EA Project No.: 16-1100

DATE OF ISSUANCE: February 14, 2017

Notice: This addendum is issued to all prospective bidders as an amendment to the Drawings and Project Manual for the Canopy Row. Bidders shall acknowledge this addendum on the Bid Form. All information contained herein shall be fully incorporated into the Contract Documents as though originally included therein.

M121

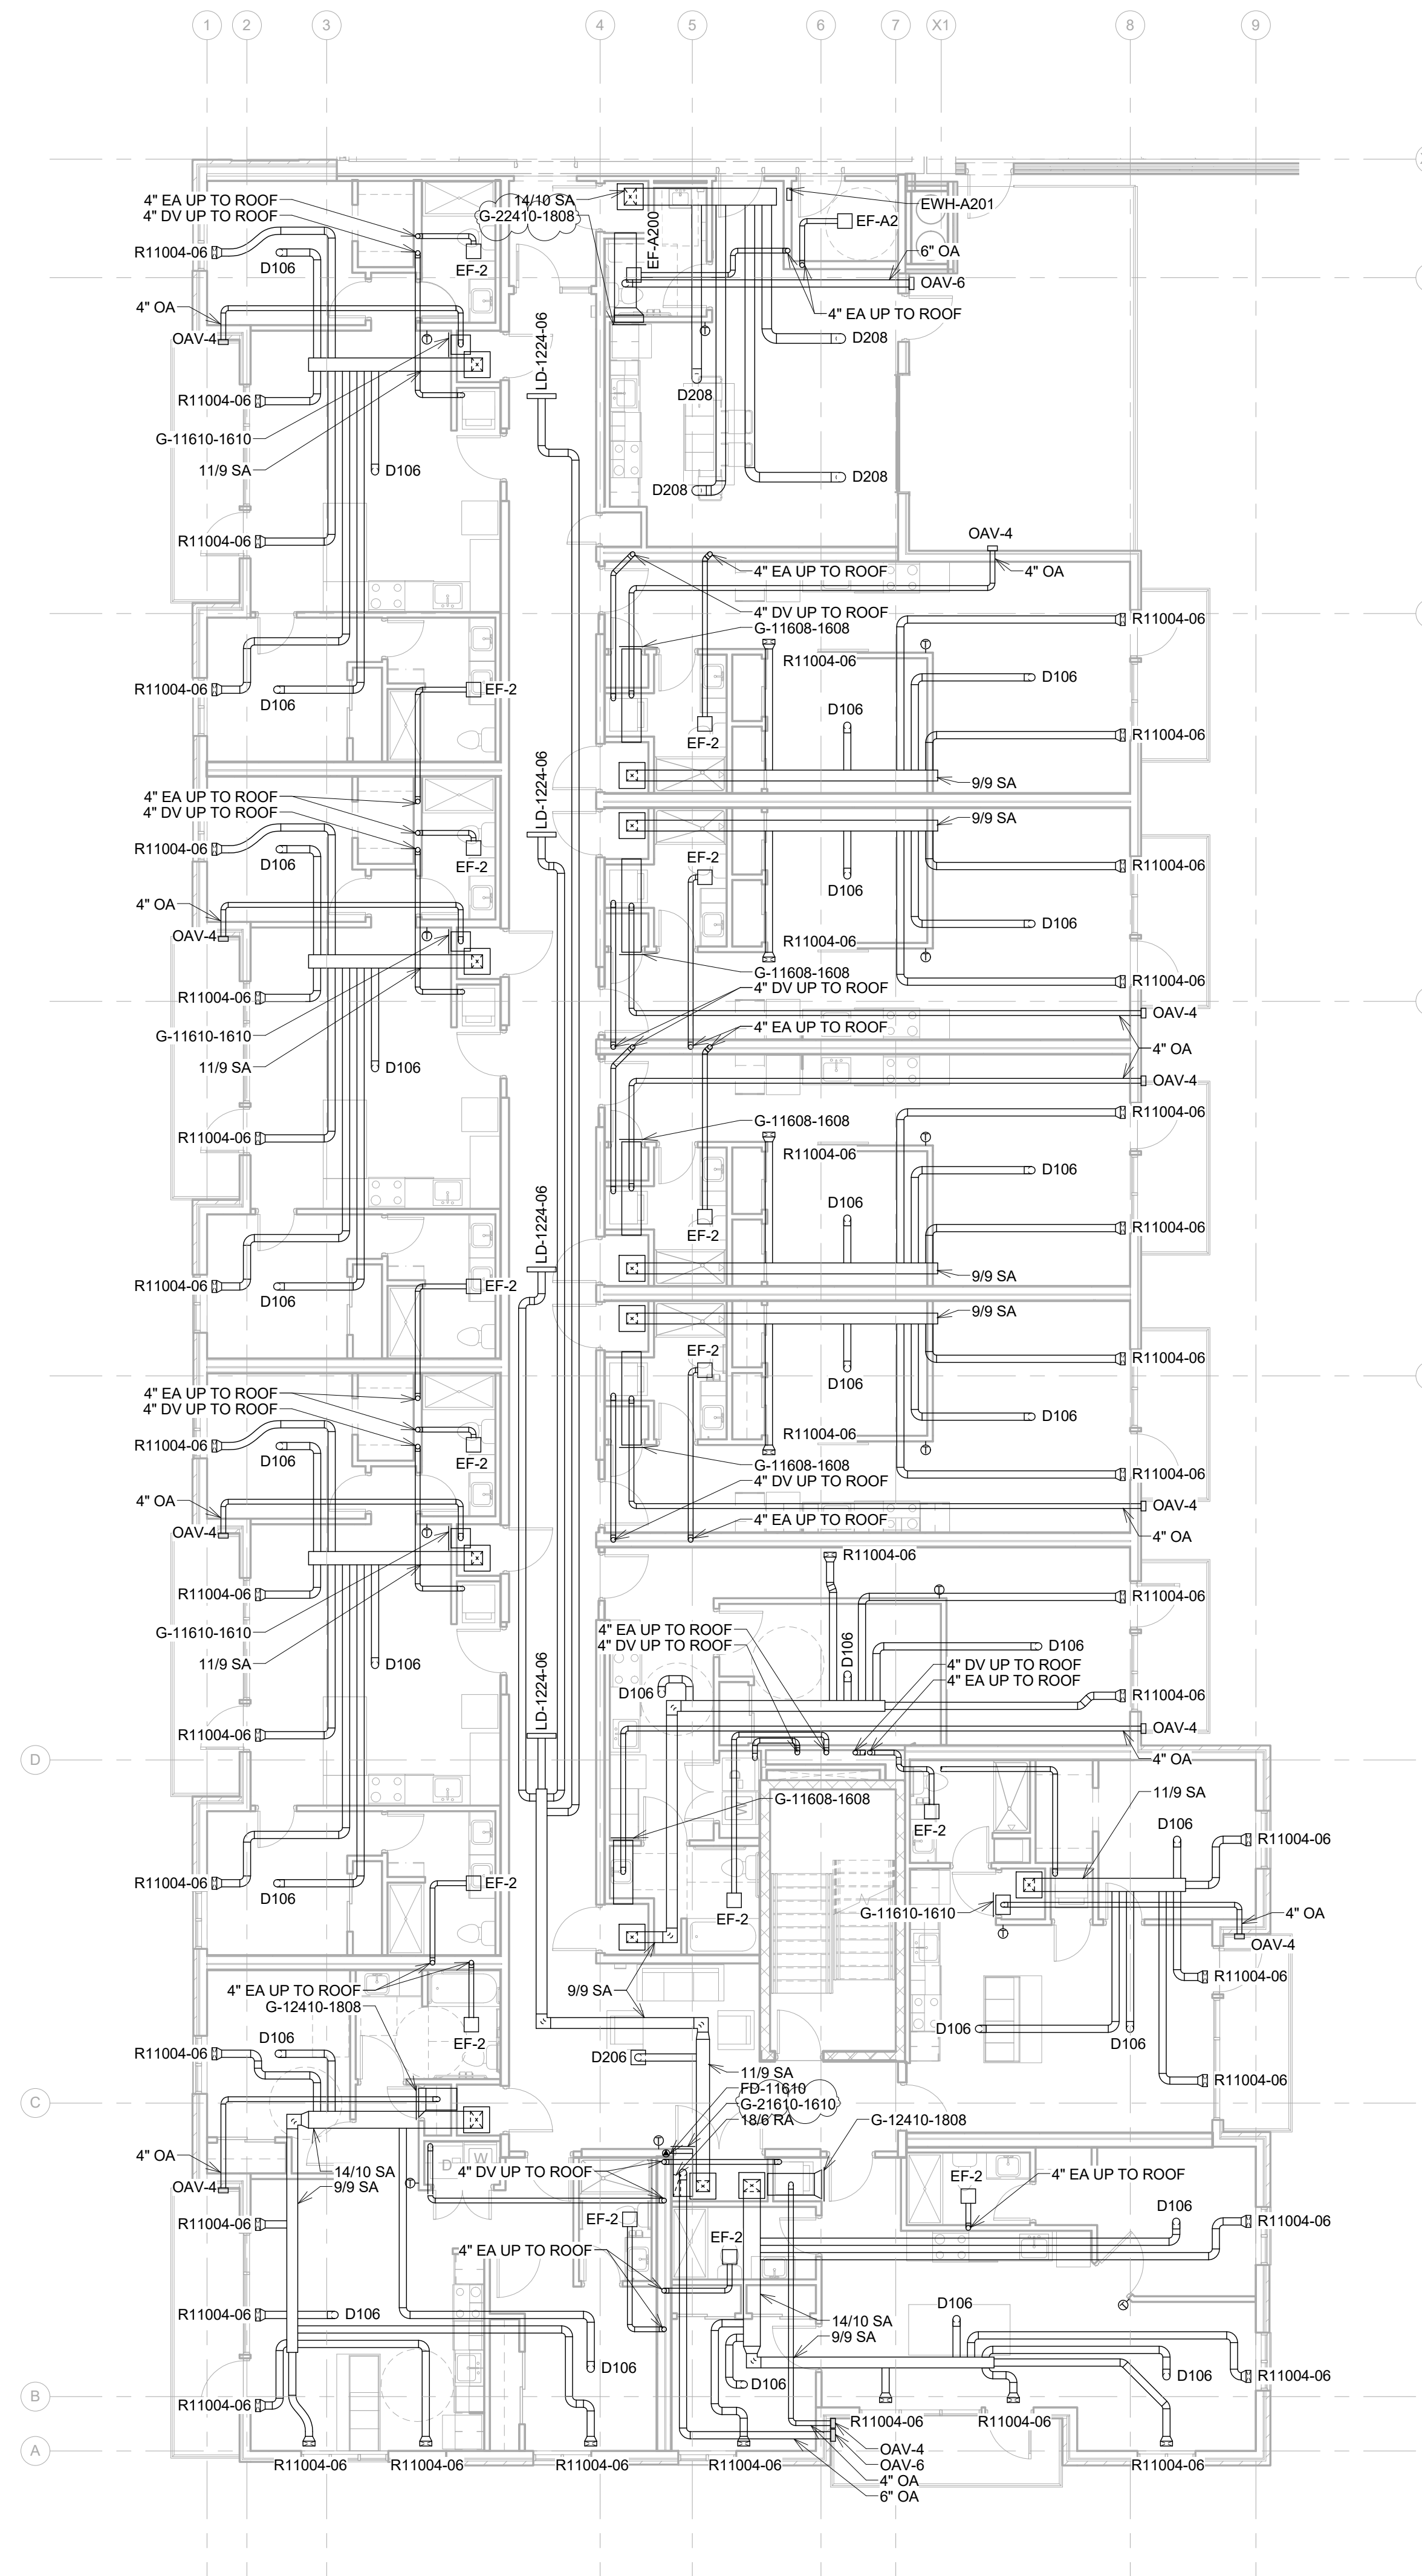
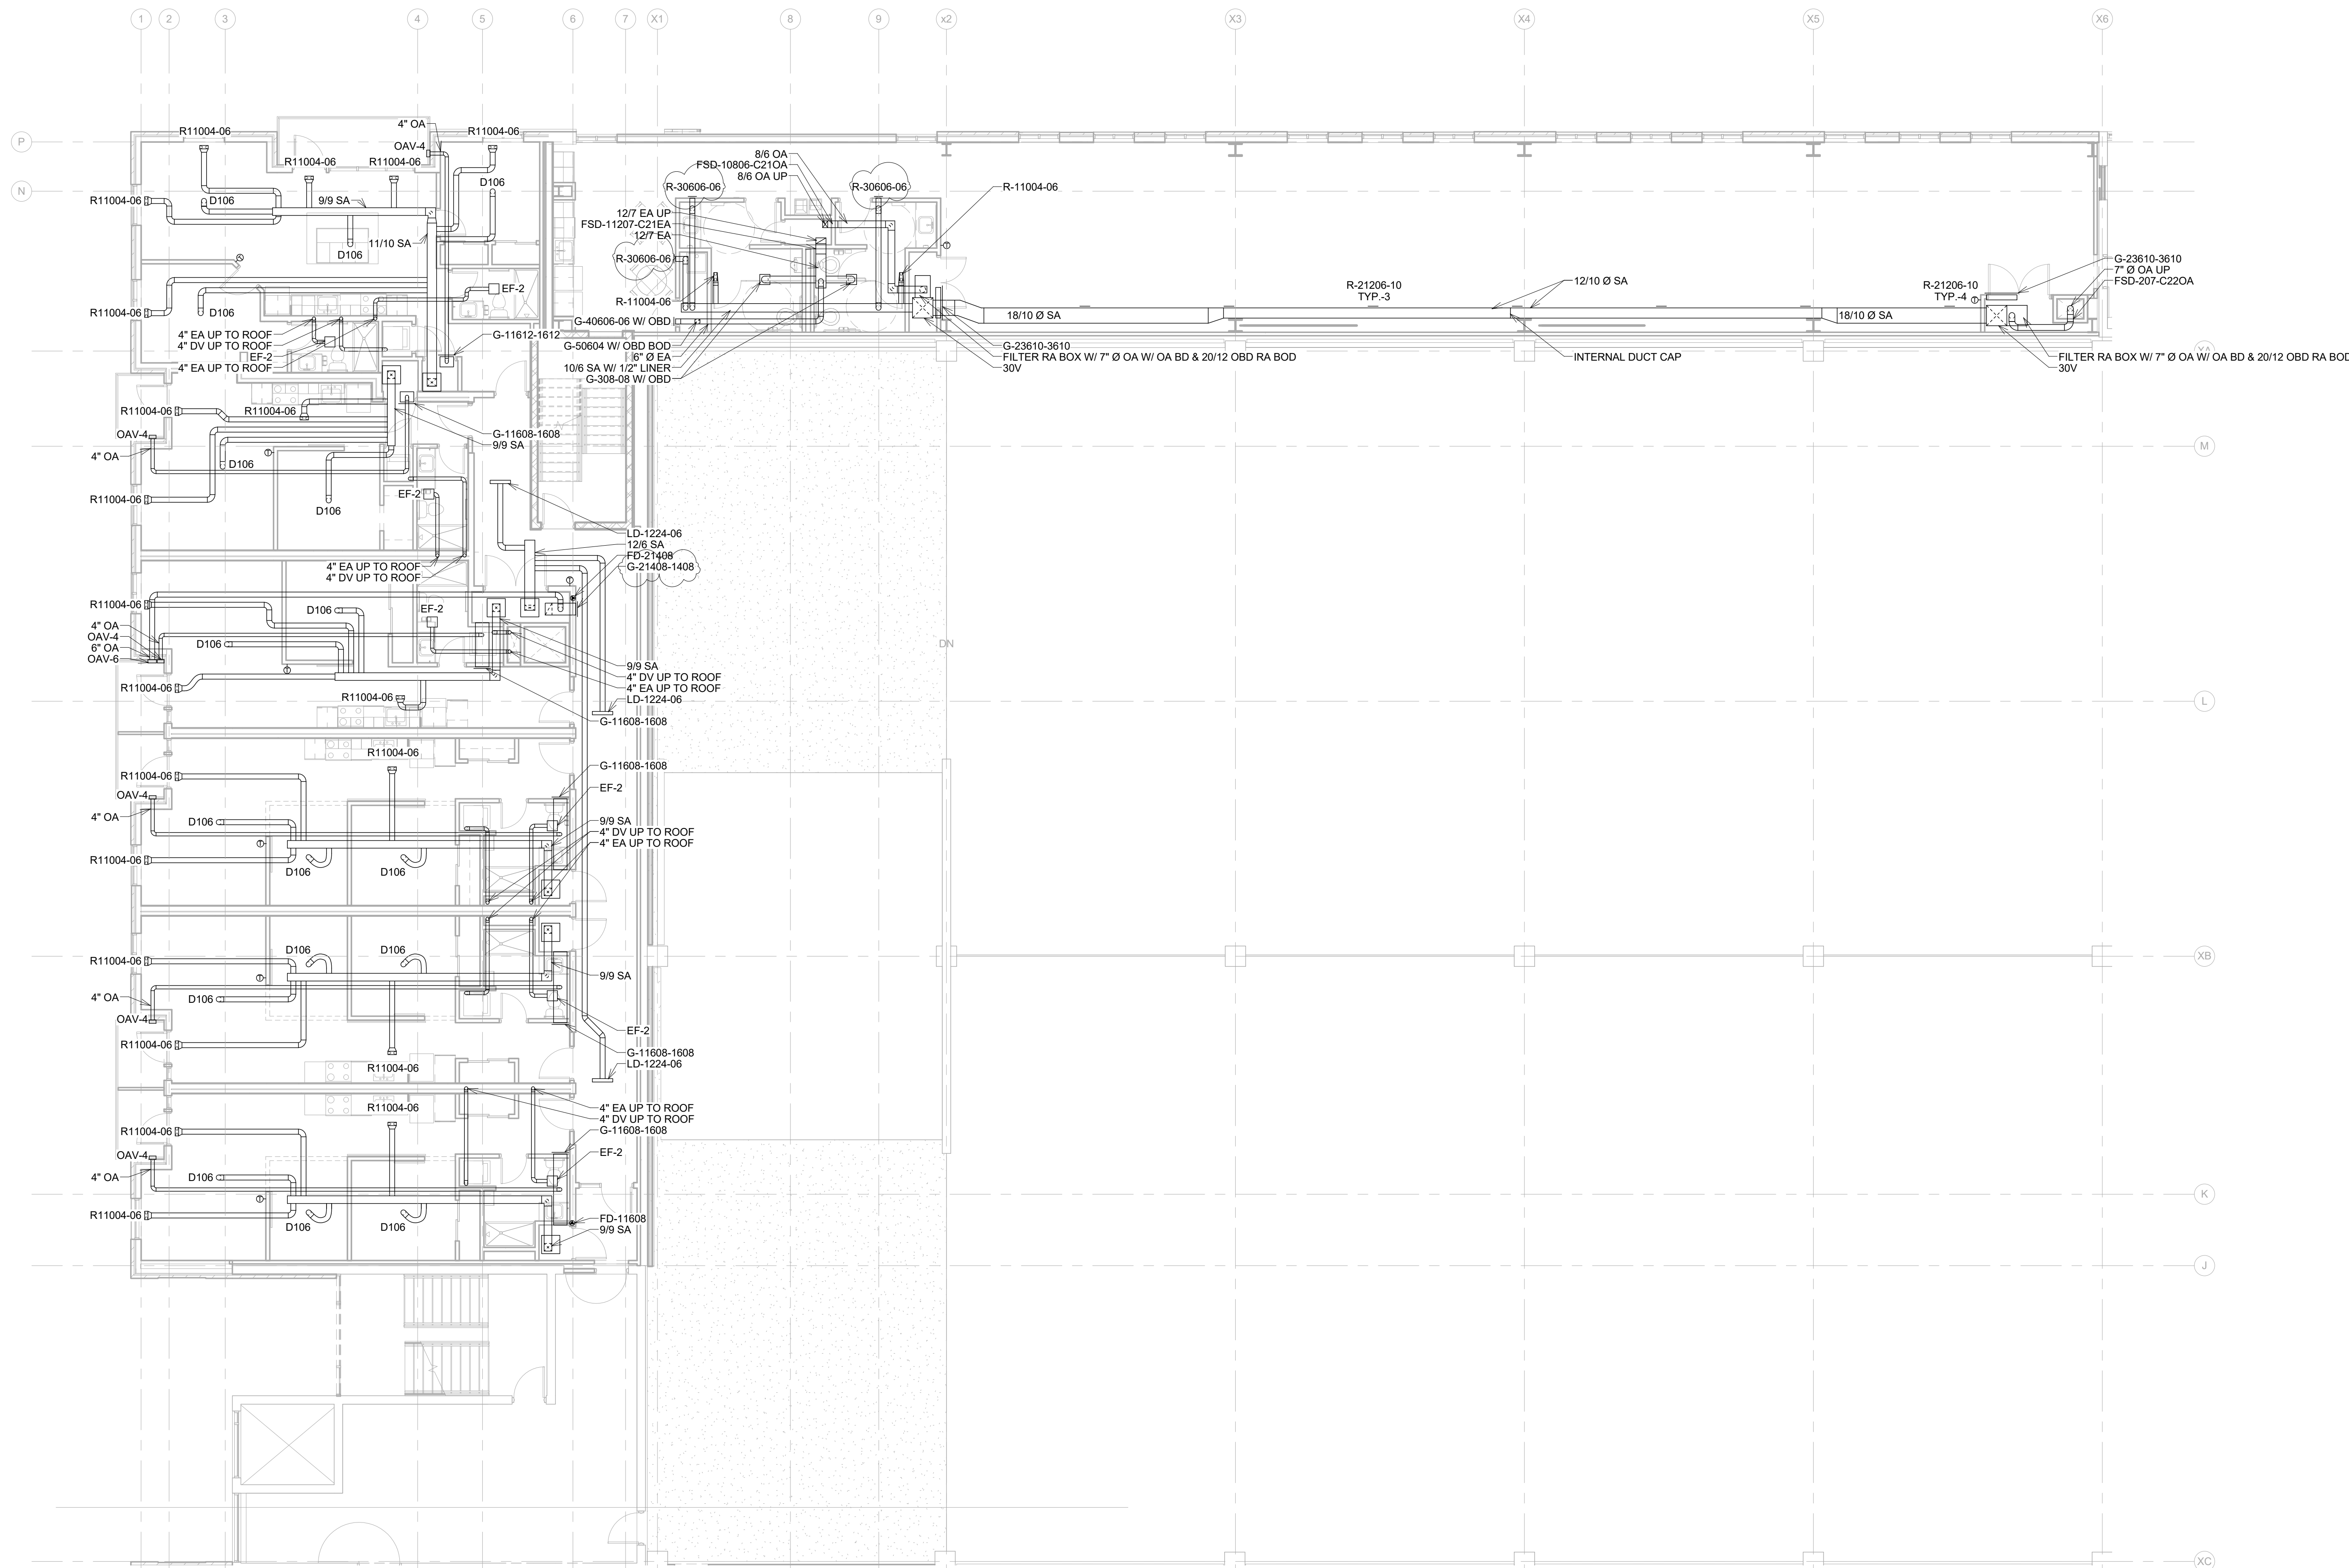
Reference Revised Sheet M121

Mechanical Room A231 change G-11610-1610 to G21610-1610.

Common A200 change G-12410-1808 to G-22410-1808.

SECOND FLOOR HVAC
ADDENDUM 2: CHANGE NOTE TO "G22410-1808" (WAS "G12410-1808") IN COMMON
ROOM A230; CHANGE NOTE TO "G21610-1610" (WAS "G11610-1610") IN MECHANICAL
ROOM A231

M122

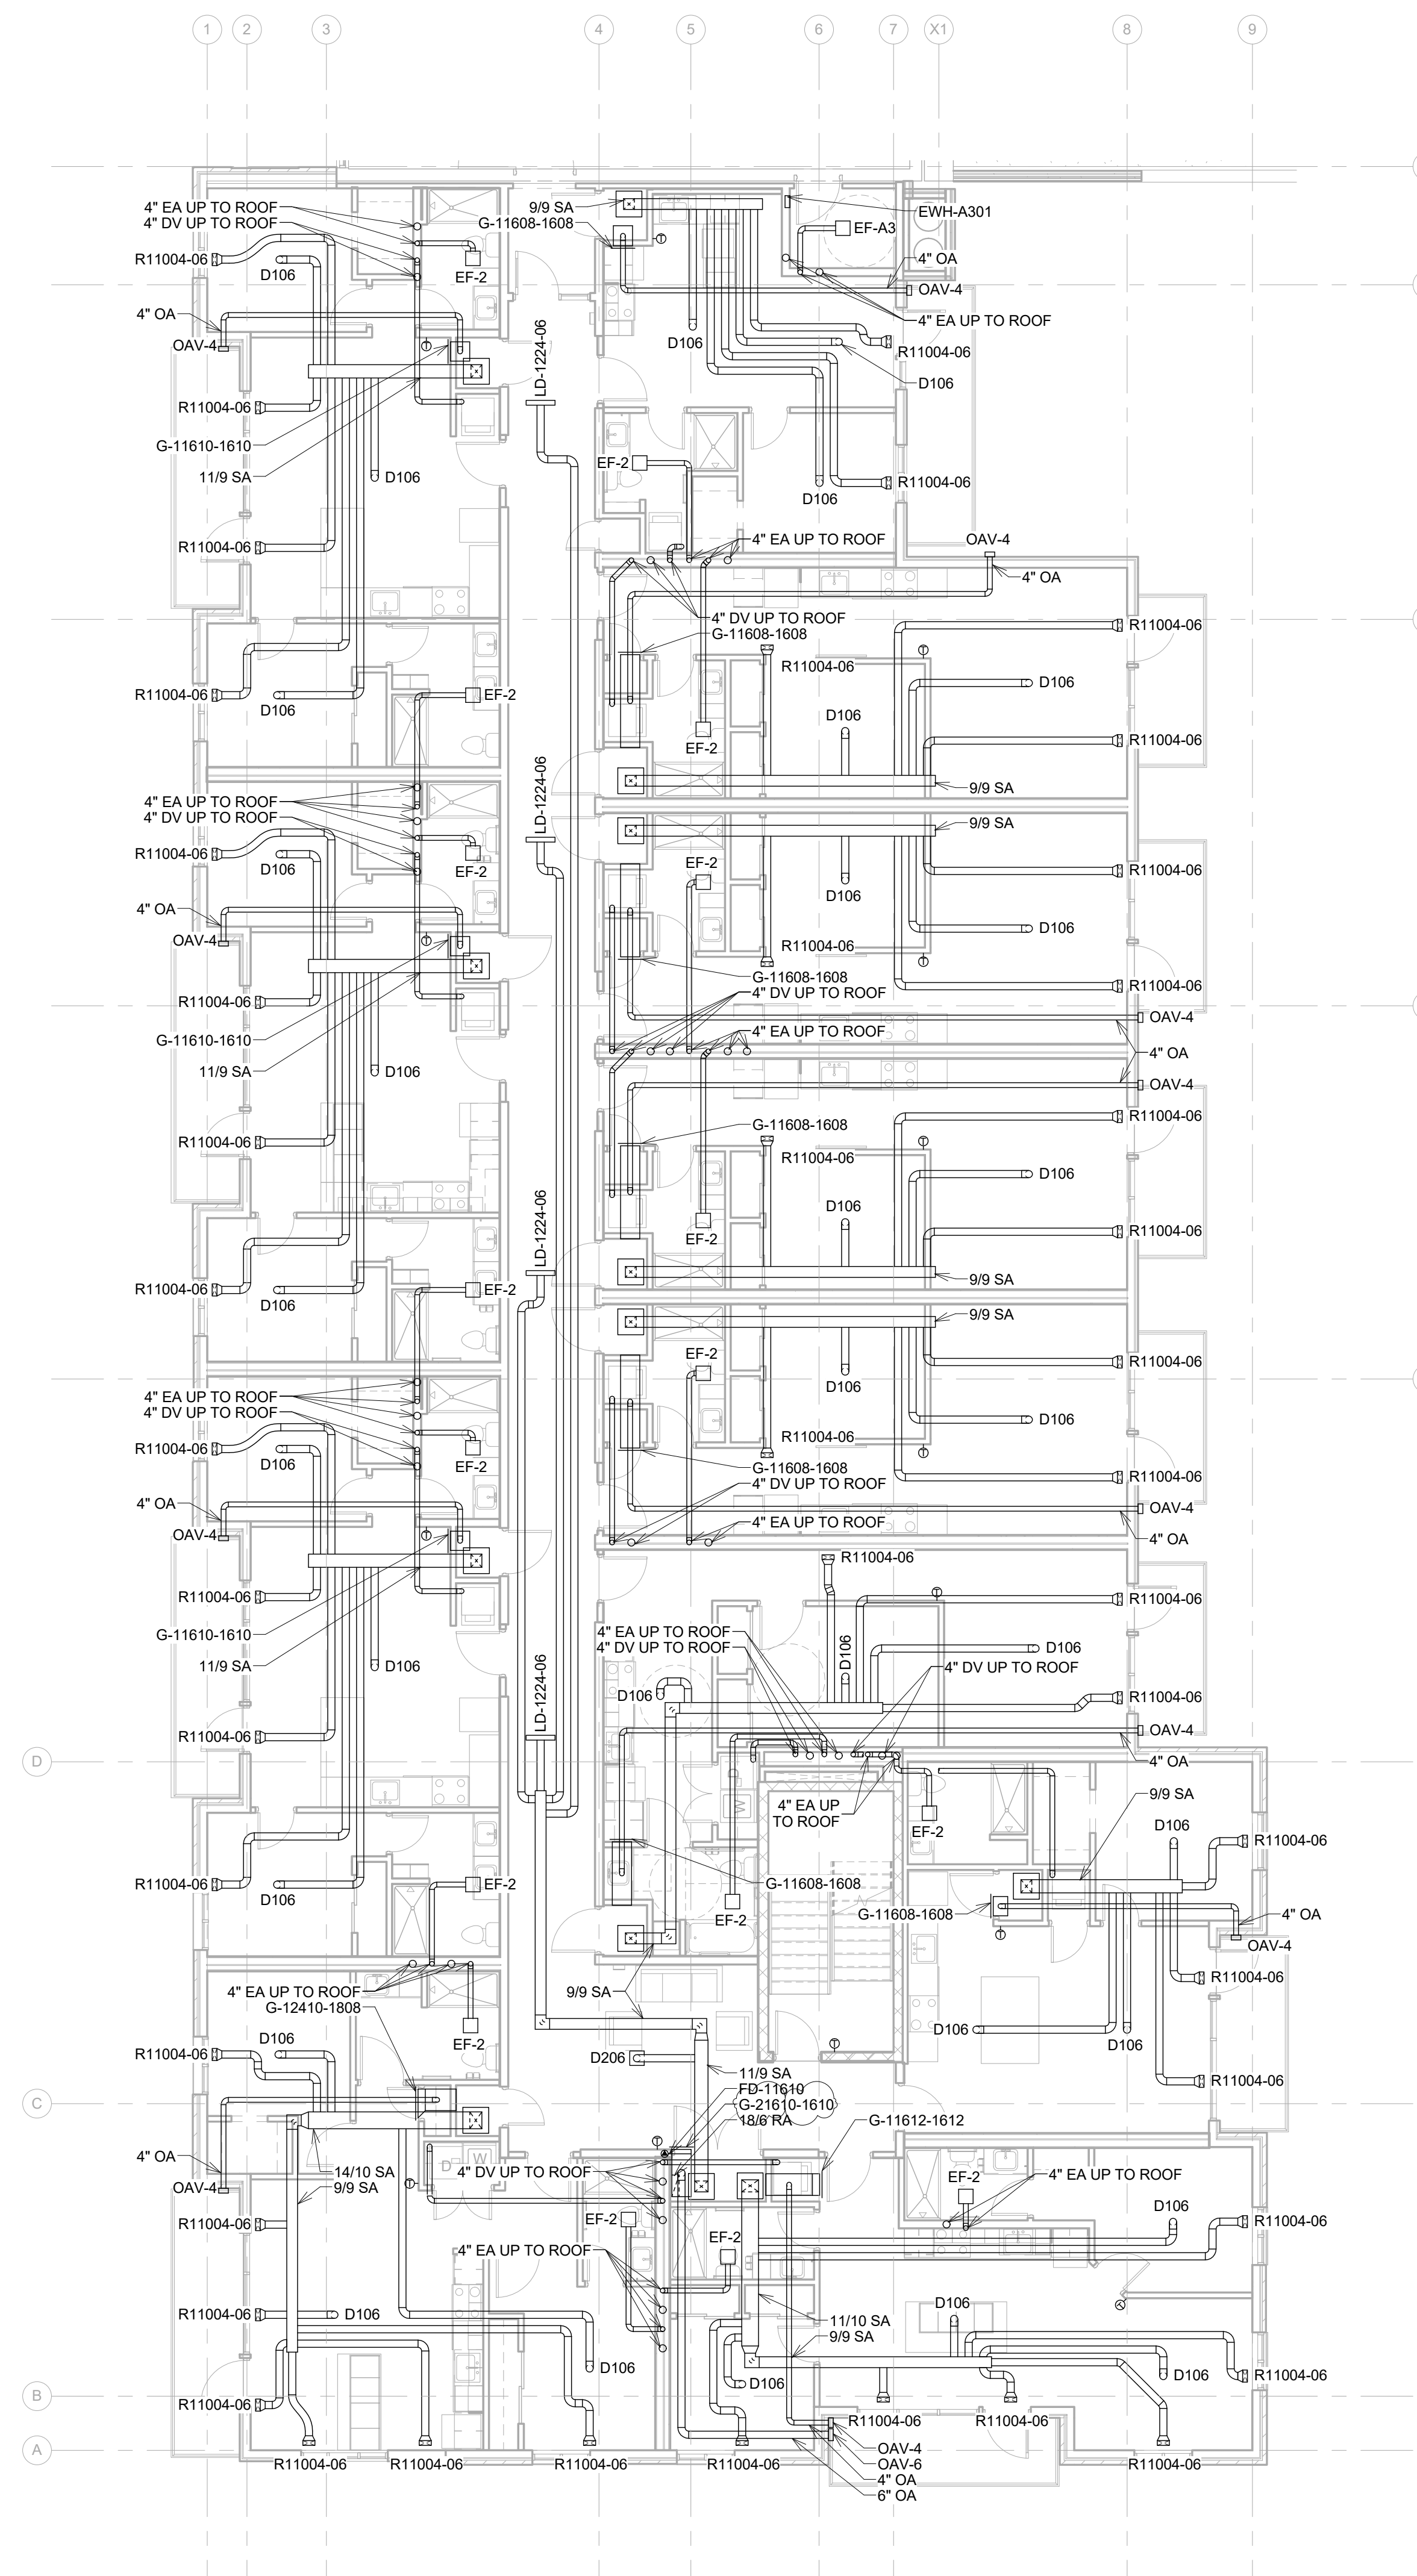
Reference Revised Sheet M122

Mechanical Room B215 change G-11408-1408 to G21408-1408.

Office C200 corridor and kitchen change 3 each R20606-06 to R30606-06.
